# Product Change Notification

**Change Notification #:** 113324 - 00  
**Change Title:** Intel® Server System R2312GL4GS  
PCN 113324-00, Product Design  
Update the System Rear Panel, Resistors and  
Capacitors  
**Date of Publication:** October 29, 2014

Figure One

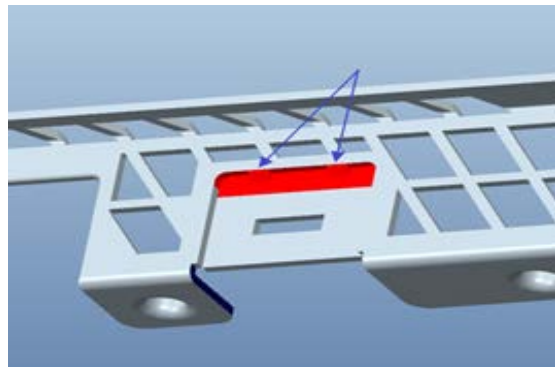
1. Update the one big center joint to two smaller joints so that the joints will not conflict with the LAN cable connector latch. See the Figure One.

Figure Two

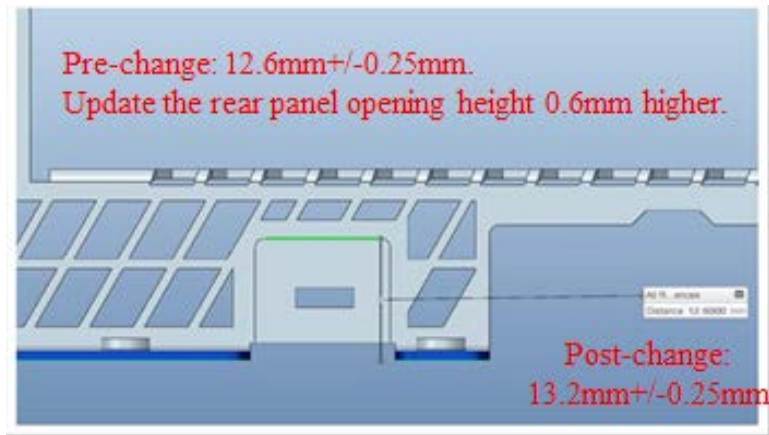
2. Update the rear panel opening height 0.6mm higher to improve the flexibility for the cable latch. The previous height was 12.6mm $\pm$ 0.25mm. The updated height is 13.2mm $\pm$ 0.25mm. See the Figure Two.

Figure Three

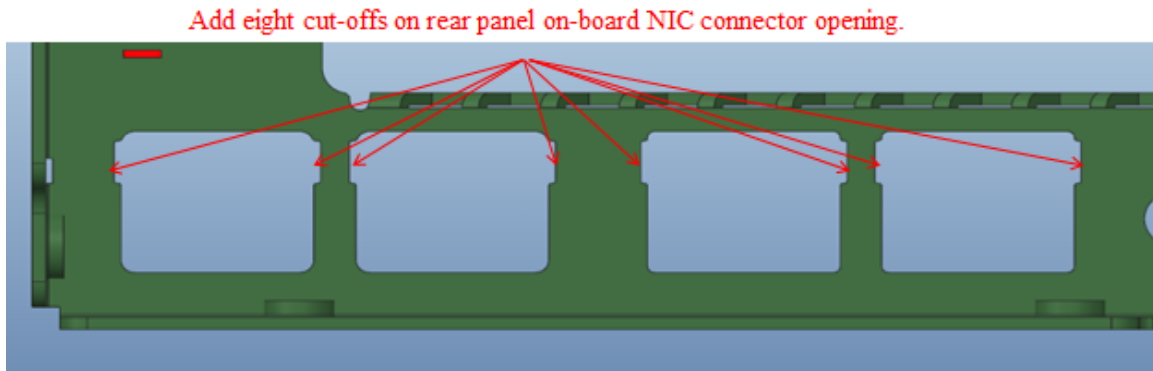
3. Add eight cut-offs around the on-board NIC (Network Interface Controller) openings to improve the LED visibility. See the Figure Three.

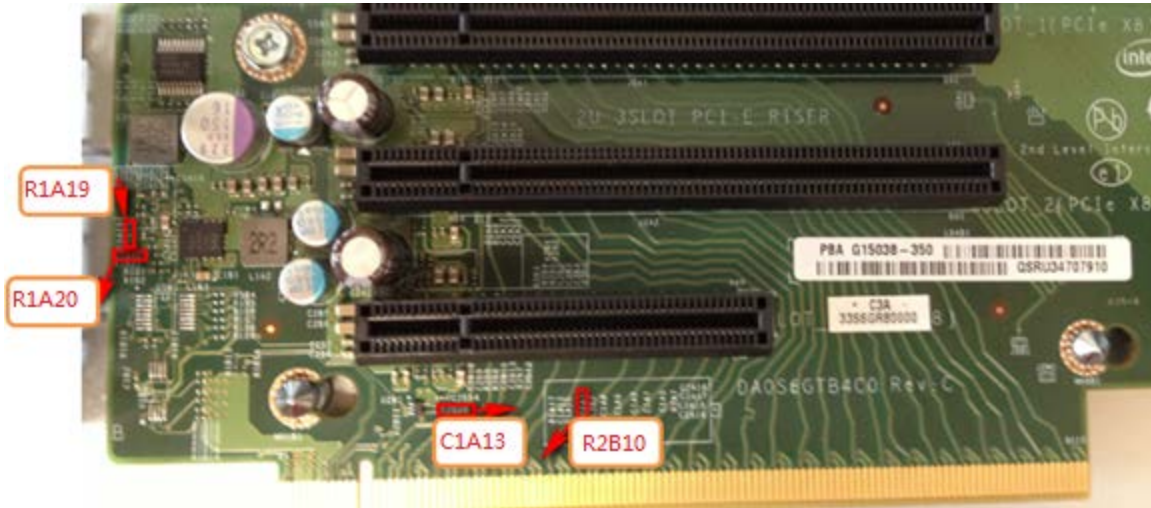
4. Update the following resistors and capacitor (see Table One and Figure Four) on the 2U PCIe Riser Spare A2UL8RISER to make an improvement to support a higher 3.3 Voltage Regulator startup over current. Before this change, the Voltage Regulator on the riser card may not be able to turn on when the total current drawn is more than 5A current. After this change, the Voltage Regulator on the riser card can support more than 10A current.

Component	Location	Pre-change	Post-change
Resistor	R2B10	10.0 kOhm	3.65 kOhm
Resistor	R1A20	0 Ohm	30 Ohm
Resistor	R1A19	40.2 kOhm	20 kOhm
Capacitor	C1A13	10 pF	120 pF
